Service Information Letter

SIL 4300-XXX-04

Electric Attitude Indicator

Inverter frequency adjustment

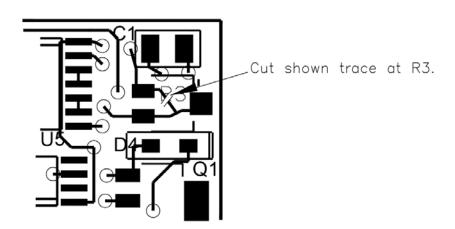
Units containing revision B or C of the inverter circuit board may have these changes made if the unit rotor speed is not sufficient to meet the calibration requirements. To perform this change one trace will need to be cut, the 1K trim pot added and resistor R2 changed to a 680 ohm value.

i) Cut trace from U5C pin 6 to R2. See diagram for location.

Carefully solder 1K ohm trim pot across the cut trace. Align the trim pot so that the adjustment screw is toward the end of the inverter circuit board as shown.

iii) Remove R2 from opposite side of the board and replace with a 680 ohm resistor.

iv) Connect the unit to the rated power and check rotor rotation direction. The rotor should spin clockwise when viewing from the bottom. Allow the unit to warm up for 10 minutes minimum. Check rotor speed for 16,500 to 17,500 RPM. If the rotor speed is not within, adjust the inverter frequency by 10Hz for each 300 RPM change required. Wait at least 3 minutes between adjustments for the rotor speed to stabilize.
